Technical Service Information

MERCEDES 722.3 /.4 HARSH ENGAGEMENT INTO REVERSE ONLY

- 8 - Mounting screw, primary pump
23- Ball valve
24- Retaining washer

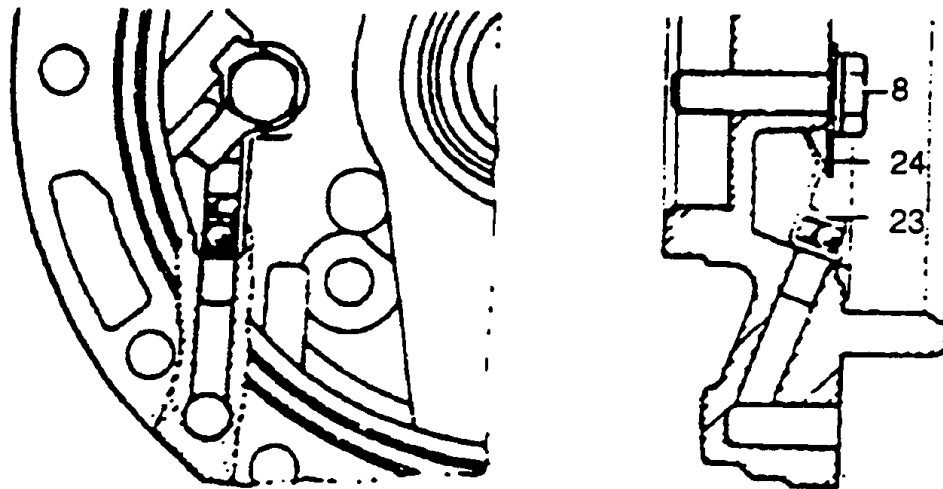
- COMPLAINT:** Harsh engagement in reverse only.
- CAUSE:** Ball valve in the front transmission cover is defective.
- CORRECTION:** Replace ball valve, part #201270 03 89, and install retaining washer (24), part number 000 463 008403 (Figure 1).
- Production Phase-in of retaining washer: As of trans end #316 257.
- NOTE** Take ball from package only shortly before installation, otherwise the plastic becomes brittle when it dries out and can break during installation.
